# POST DEVELOPMENT DRAINAGE PLAN

PROJECT: WATerview NORTH  
SHEET TITLE: POST DEVELOPMENT DRAINAGE PLAN  
FROM: n/a TO: n/a  
JOB NO.: 02-19-05 SHEET: 3 OF 3

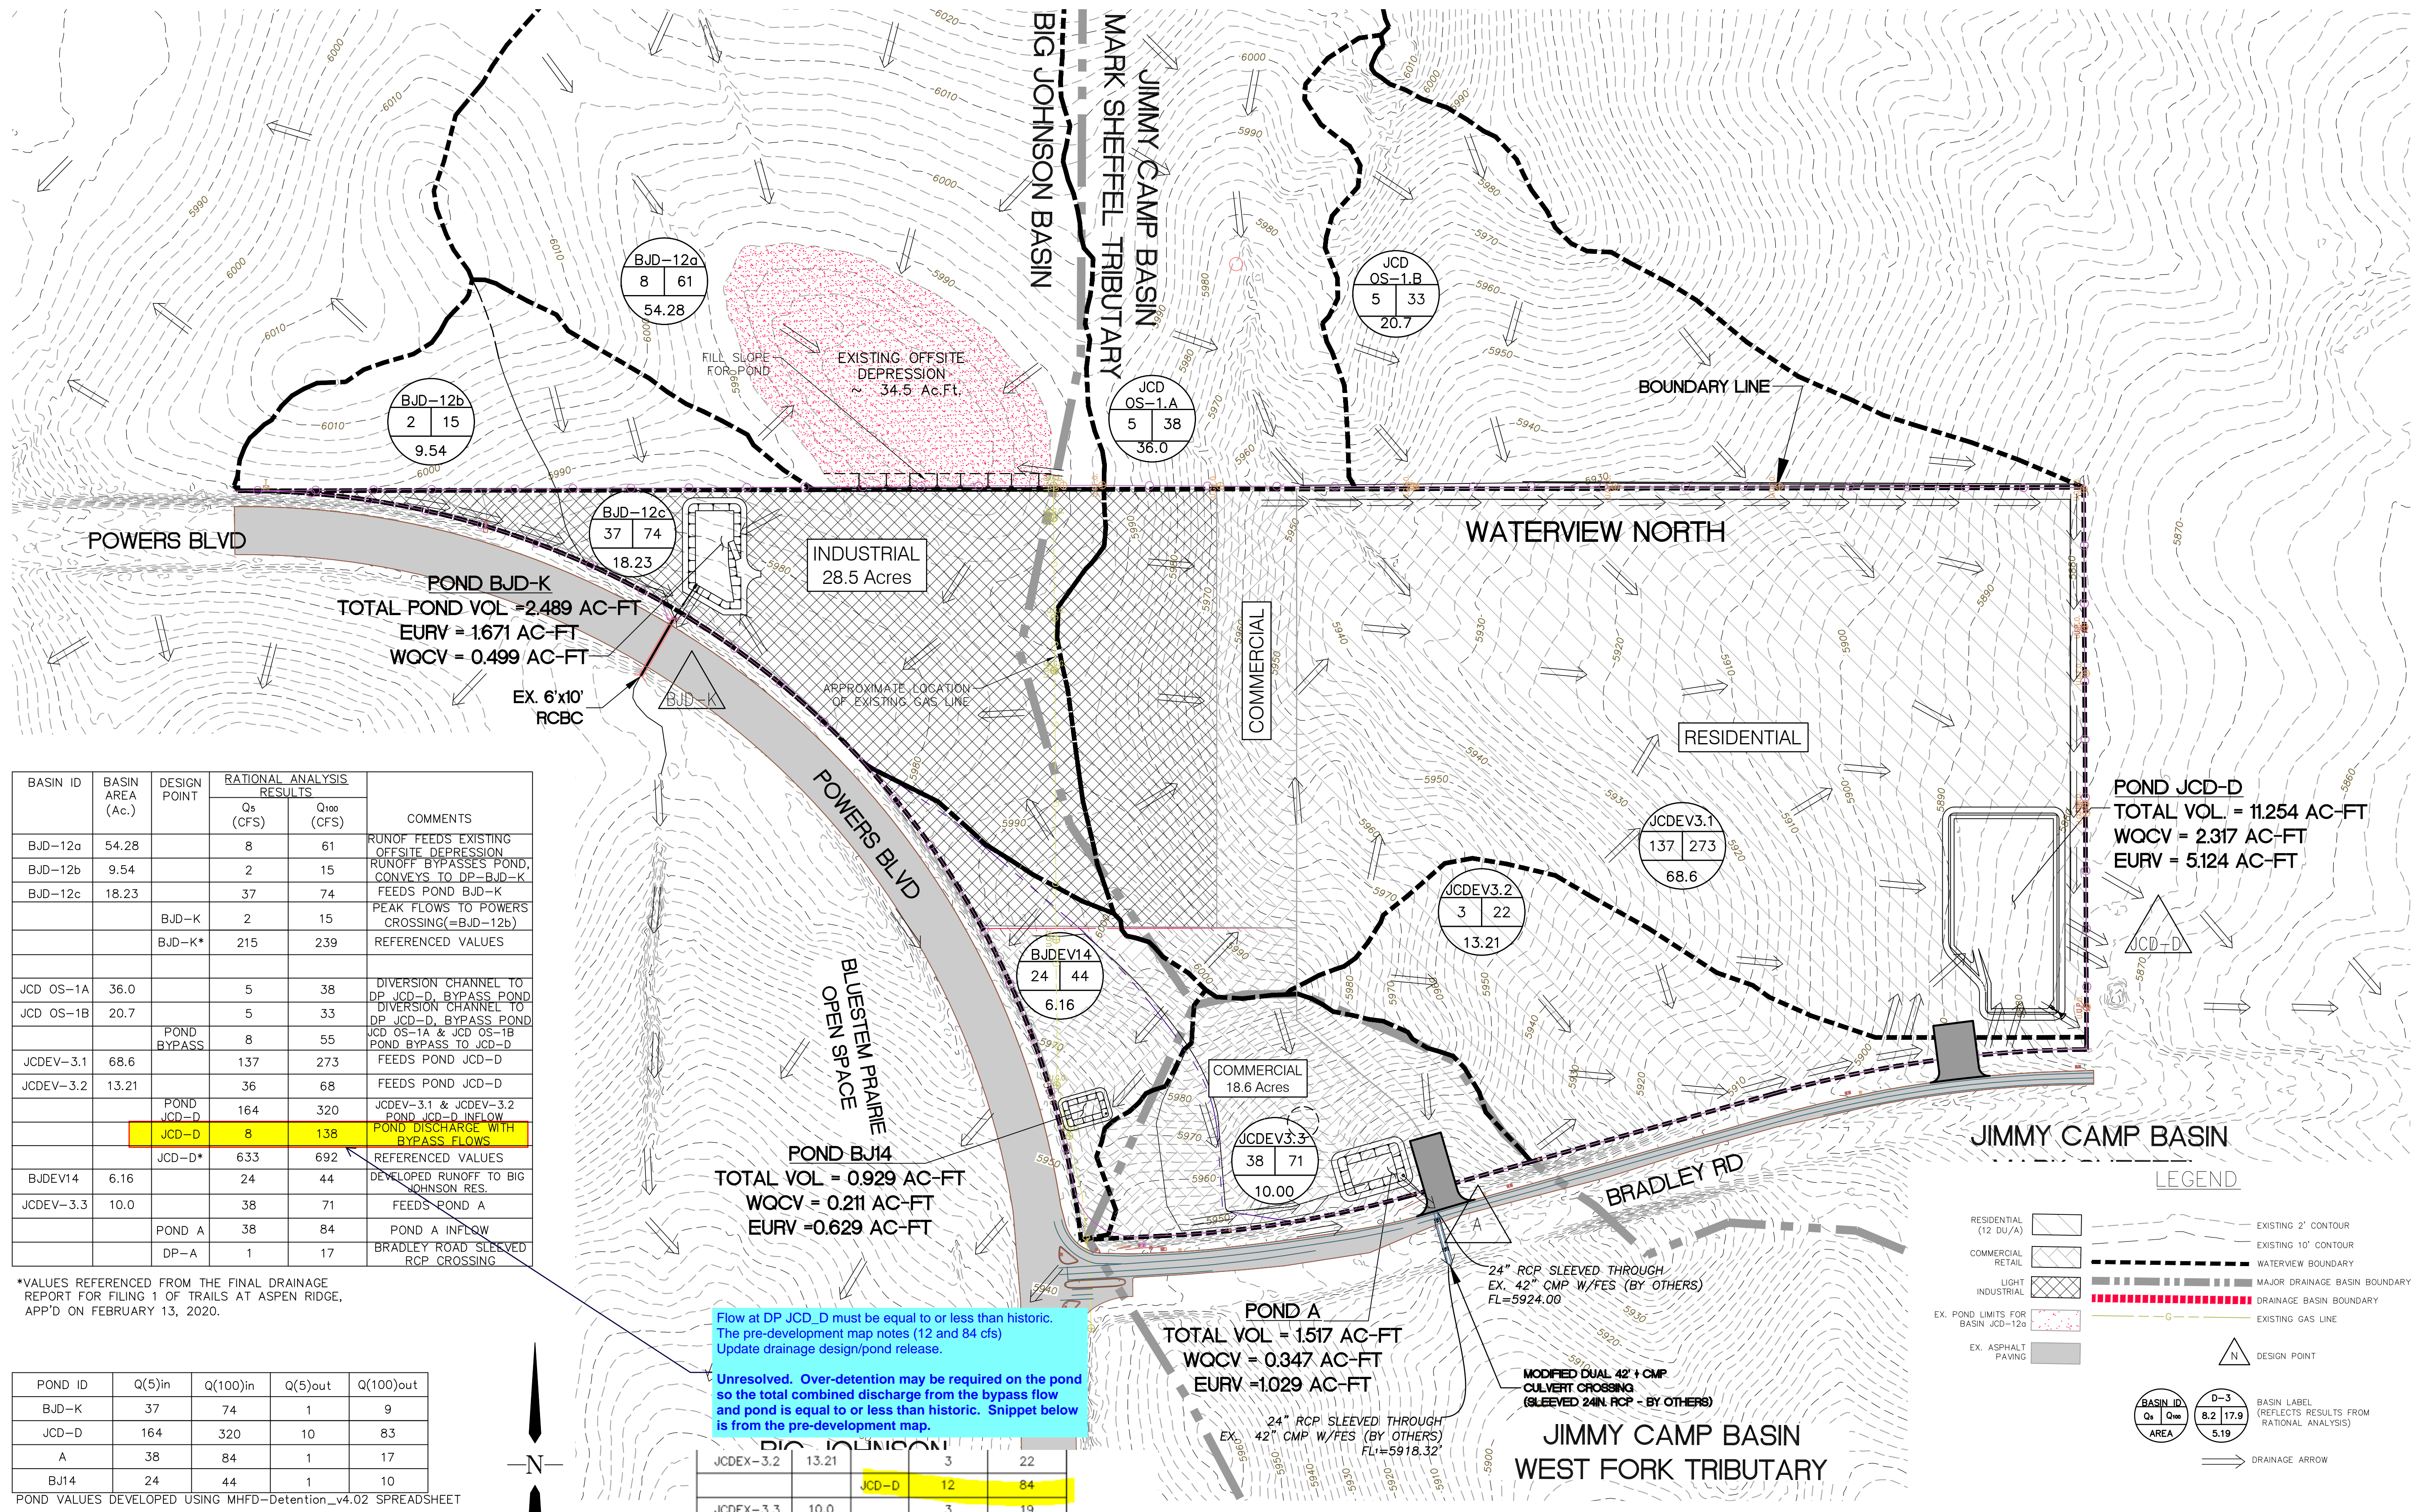
Flow at DP JCD\_D must be equal to or less than historic. The pre-development map notes (12 and 84 cfs) Update drainage design/pond release.

Unresolved. Over-detention may be required on the pond so the total combined discharge from the bypass flow and pond is equal to or less than historic. Snippet below is from the pre-development map.

DSE Response: Updated chart to appropriate flows
